SAN MATEO COUNTY FIRE DEPARTMENT OFFICE OF THE FIRE MARSHAL

This application is for a request for Alternate Materials and Methods of Construction or Alternate Design as allowed under the authority of Section 104.9 of the California Fire Code. Applicant must submit two copies by a Licensed engineer, Architect or Fire Protection Engineer depending on the request.

570 LIVE OAK LANE			BLD 2022-00389
Occupancy Group:	Type of Construction:	Fire Sprinklers (Y/N):	No. of Stories:
U/R-3		YES	2
Total Floor Area:	Floor Area Per Floor:	Tenant Floor Area:	Project APN#
3257	MAX. 1392	N.A.	057-163-090
Describe End Use: SINGLE-FAMILY DWELLING WITH ATTACHED ADU			
SUBJECT OF ALTERNATIVE			
(Separate forms should be filled out for each different item): PROVIDE EXPANDED TURNAROUND AT THE END OF DEVELOPED/PAVED LIVE OAK LANE. PROVIDE AN AUTOMATIC FIRE SPRINKLER SYSTEM BASED ON A 4-HEAD CALCULATION.			
CODE REQUIREMENT			
(Specify code edition and section): REQUEST MADE UNDER SEC. 104.90 OF CFC. DETERMINATION OF SPECIFIC FIRE CODE SECTIONS FOR WHICH AN ALTERNATE MEANS IS PROPOSED TO BE ISSUED BY THE OFFICE OF THE FIRE MARSHAL.			
ALTERNATE PROPOSED ————————————————————————————————————			
(Attach deta

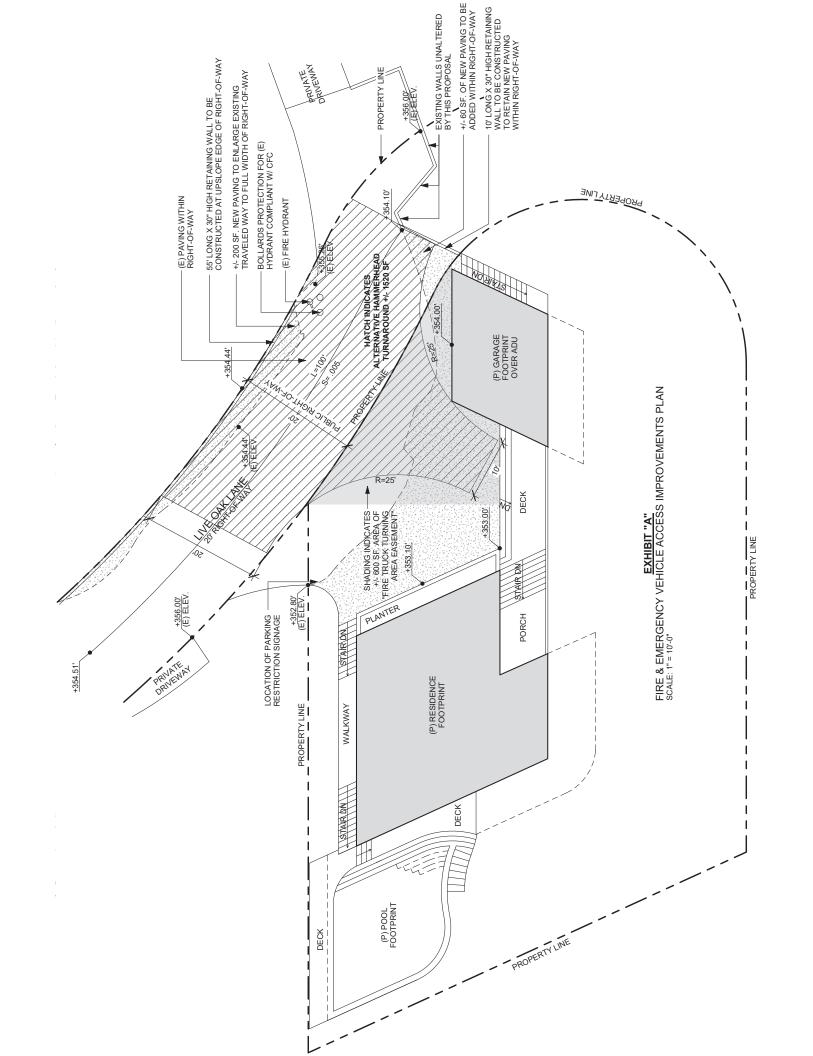
- 1. Fire sprinkler system within the proposed dwelling to be based on a four (4) head calculation.
- 2. The area of paving within the public right-of-way must be expanded as illustrated on attached Exhibit "A". A copy of the Maintenance Agreement associated with these new improvements as prepared by San Mateo County Public Works, executed by the property owners and recorded in the offices of the County Recorder must be provided to the Fire Marshal prior to the securing of a final inspection of improvements proposed under BLD2022-00389.

- 3. A Fire Truck turning Area Easement based on the attached Exhibit "A" must be prepared, executed and recorded prior to the scheduling of a final inspection of improvements described on BLD2022-00389. Easement documents must specify that no long term (overnight) parking is permitted within the designated easement area. Copies of all recorded easement-related documentation must be provided to the Fire Marshal.
